Ridgway Town Council
Special Meeting Agenda
Wednesday, August 3, 2022

1. **Application:** Preliminary Plat for Subdivision and Planned Unit Development; **Location:** Town of Ridgway, Block 30, Lots 1-12; **Zone:** Historic Residential (HR); **Applicant:** David Bruce; **Owner:** Ridgway Homes, LLC

To: Town of Ridgway Planning Commission
Cc: Preston Neill, Ridgway Town Manager
From: TJ Dlubac, CPS, Contracted Town Planner
Date: July 29, 2022
Subject: Yellow Brick Lane Sketch Plan and Preliminary Plat for Subdivision and PUD Staff Report for August 3rd Special Town Council Meeting

Sheet
SW1.01

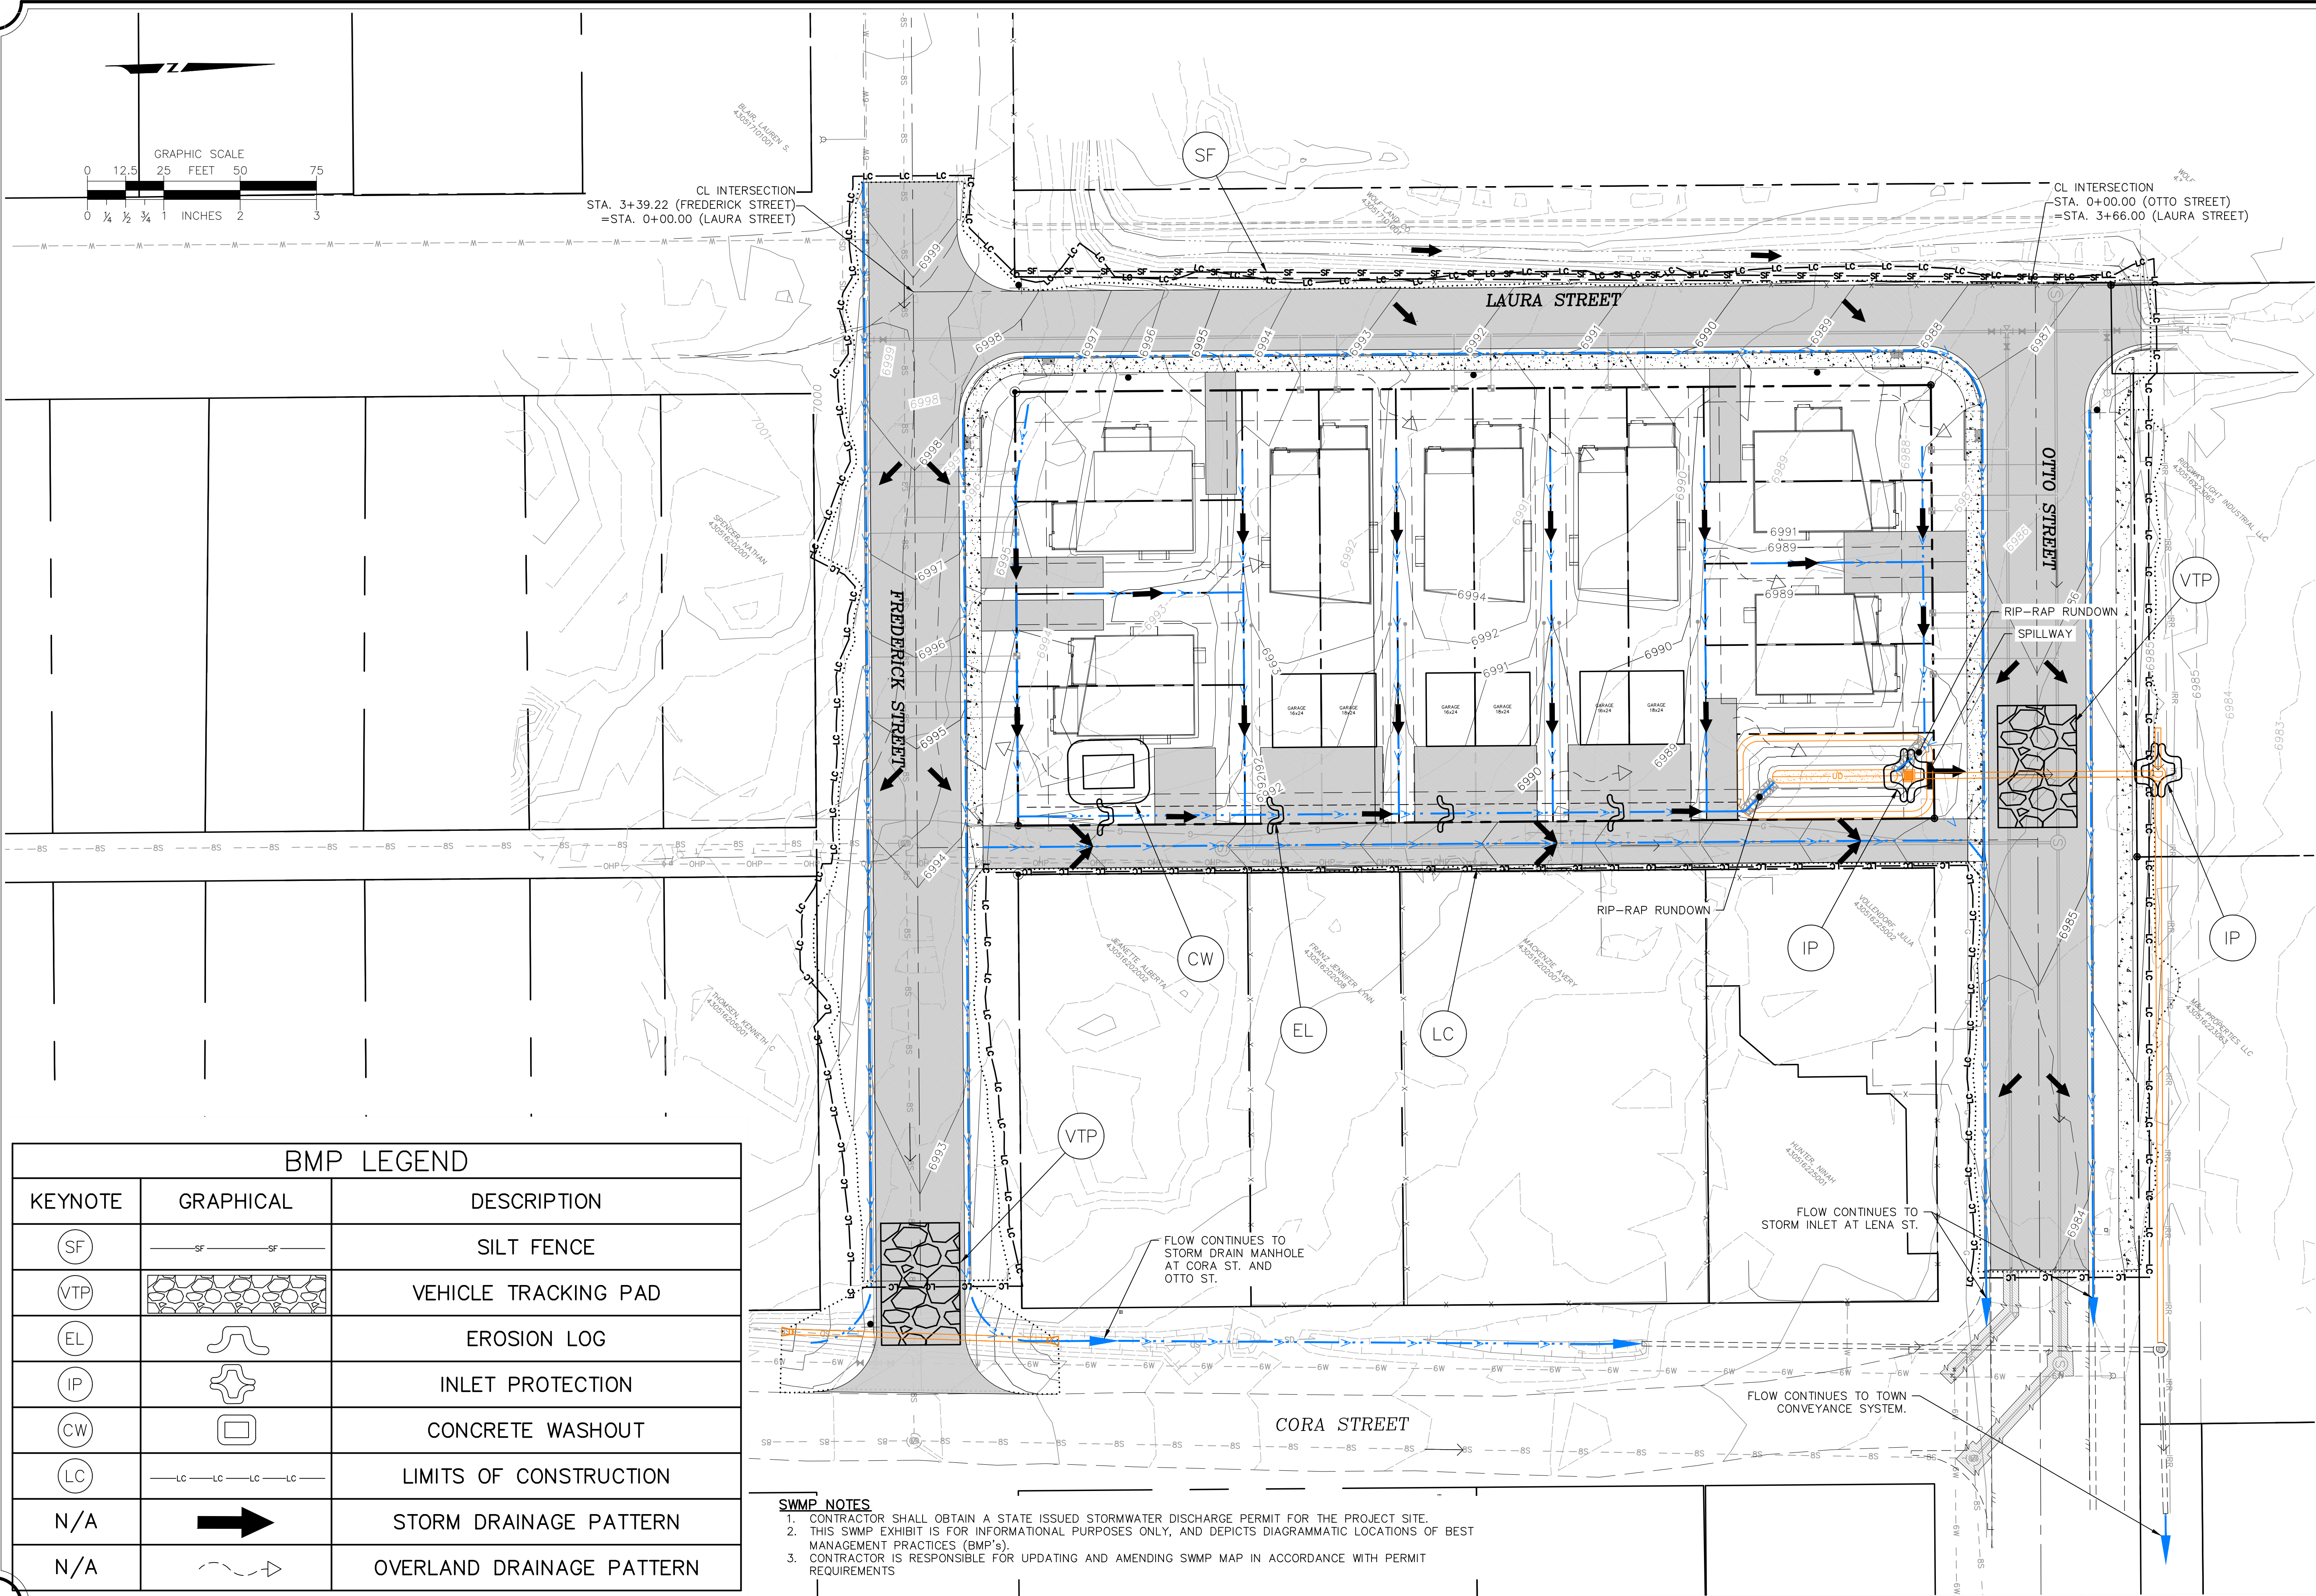
Document	Pg	Sht Name	Detail	Goff Comments	Town 070122	Goff Comments	
Civil Plans	26	SW1.01	Storm		There is no forebay for the basin. Required by standards because it eases maintenance and without it the effectiveness and infiltration rate of the filter media will decrease rapidly	Forebay will be incorporated into pond facility. Revised drainage report forthcoming July 22nd.	No forebays have been seen on any documents.
Civil Plans	26	SW1.01	Storm		What's the maintenance plan for the basin?	Tract A will be owned and maintained by Ridgway Homes LLC and its dedication has been amended on the Plat.	Concerned about post the LLC
Civil Plans	25		Storm		Why no inlets at curb and gutter? Confirm with RLI plans whether it is needed.	Per review of RLI development plans, historic and developed drainage pattern trends northeasterly. No underground conveyance systems are proposed as part of RLI improvement plans.	Ok
